Addendum 1

January 10, 2013

State of Nebraska HVAC Replacement for South Cottages
Beatrice State Developmental Center

Alvine No. 2011 2582

GAS WATER HEATER DETAIL

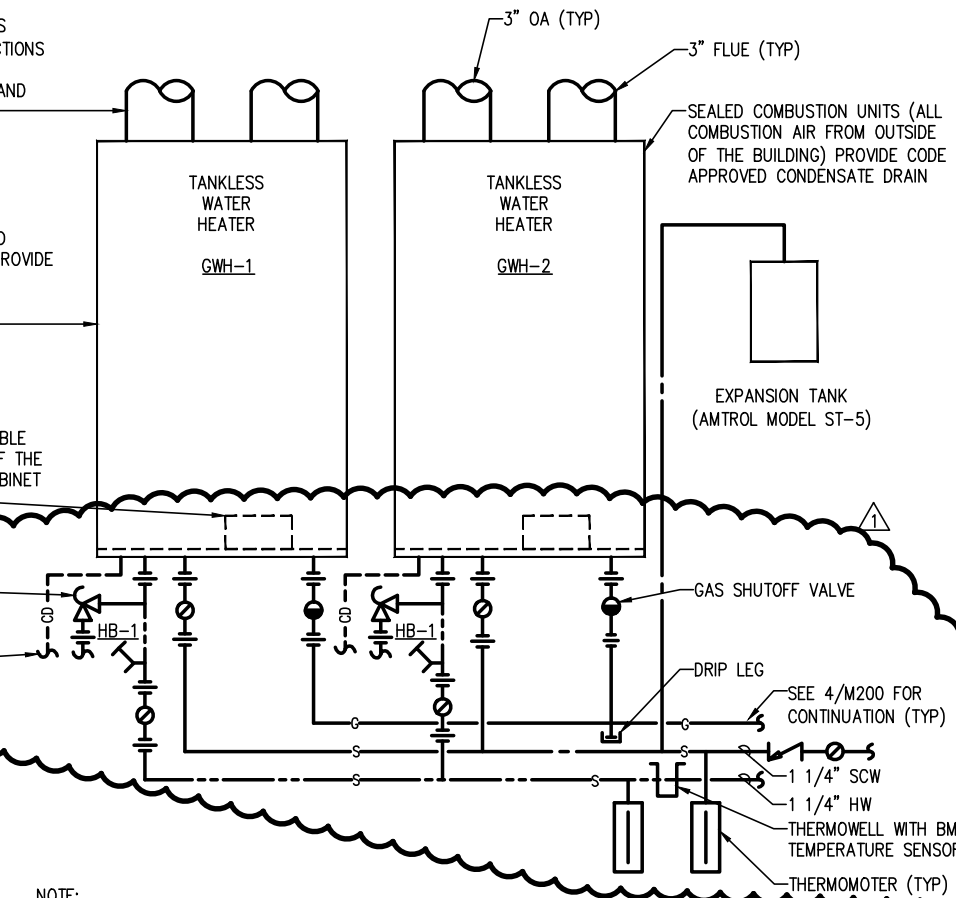
1MD3. Sheet M300 - Enlarged Floor Plans - Mechanical

1. Modify the Gas Water Heater Detail 2/M300 as indicated on attached Mechanical Sketch Sheet MS-1.

VENTING MUST COMPLY WITH NATIONAL CODES, LOCAL CODES AND MANUFACTURER'S INSTRUCTIONS COORDINATE ROUTING AND TERMINATION WITH DUCTWORK AND OUTSIDE AIR INTAKES

UNIT SHALL BE WALL MOUNTED ABOVE EXISTING WALL MOUNTED DRYER VENT DUCTWORK AND PROVIDE ALL CLEARANCES PER MANUFACTURER AND CODE REQUIREMENTS (TYP)

INSTALL MOISTURE SENSING CABLE ALONG THE FULL PERIMETER OF THE BOTTOM OF WATER HEATER CABINET AND CONNECT TO BMS (TYP)

PRESSURE AND TEMPERATURE RELIEF VALVE PIPE TO FLOOR DRAIN (TYP)

ROUTE CD TO EXISTING FLOOR DRAIN (TYP)

1. FLUE AND COMBUSTION AIR PIPING SHALL BE PVC AND SHALL BE ROUTED PER MANUFACTURER'S RECOMMENDATIONS.
